Project	IEEE 802.16 Broadband Wireless Access Working Group < http://ieee802.org/16 >	
Title	Downlink Fast Feedback channel	
Date Submitted	2004-08-26	
Source(s)	Bin-Chul Ihm, Yongseok Jin, Jinyoung Chun, Kyuhyuk Chung LG Electronics, Inc. 533, Hogye-1dong, Dongan-gu, Anyang-shi, Kyongki-do, Korea	Voice: 82-31-450-7187 Fax: 82-31-450-7912 [mailto: {bcihm, jayjay, jyechun03, kyuhyuk}@lge.com]
	Dong-Cheol Lee, Chi-Man Lee, Ki-Jun Lee, Dacom 706-1, Yeoksam-Dong, Gangnam-Gu, Seoul, 135-987, Korea	Voice: 82-505-889-4248 Fax: 82-505-889-0315 [mailto: dclee@dacom.net, lcm2000@chol.com, mobile95@dacom.net]
Re:	This is a response to a Call for Comments on IEEE P802.16e-D4	
Abstract	We propose DL fast feedback channel for transmission of MIMO related information to support the closed-loop MIMO in the uplink	
Purpose	This document is submitted for review by 802.16e Working Group members	
Notice	This document has been prepared to assist IEEE 802.16. It is offered as a basis for discussion and is not binding on the contributing individual(s) or organization(s). The material in this document is subject to change in form and content after further study. The contributor(s) reserve(s) the right to

Figure xxx Mapping order of DL FAST-FEEDBACK message to the FAST-FEEDBACK region

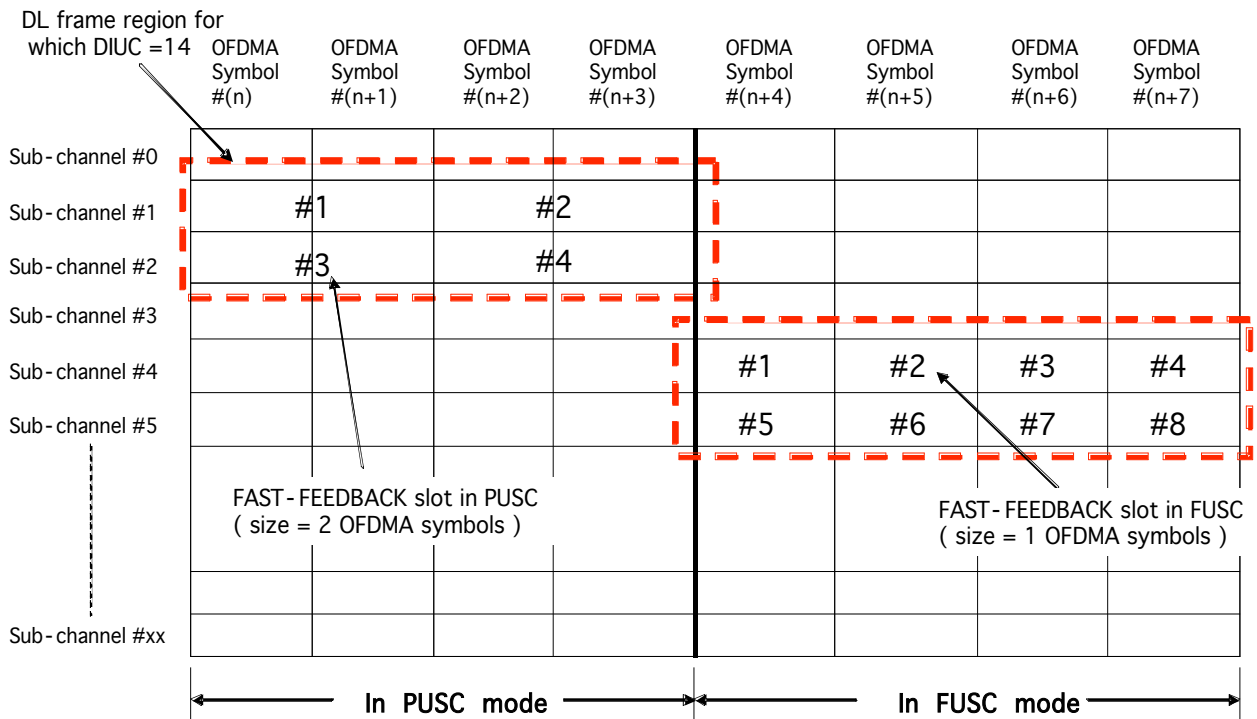
8.4.5.3.18 [DL FAST-FEEDBACK message mapping](#)

[Each DL FAST-FEEDBACK message occupies one slot according to permutation mode. DL FAST-FEEDBACK message are mapped in to the region marked by DIUC=14, in the DL-MAP, in a time-first order, as shown in Figure xxx](#)
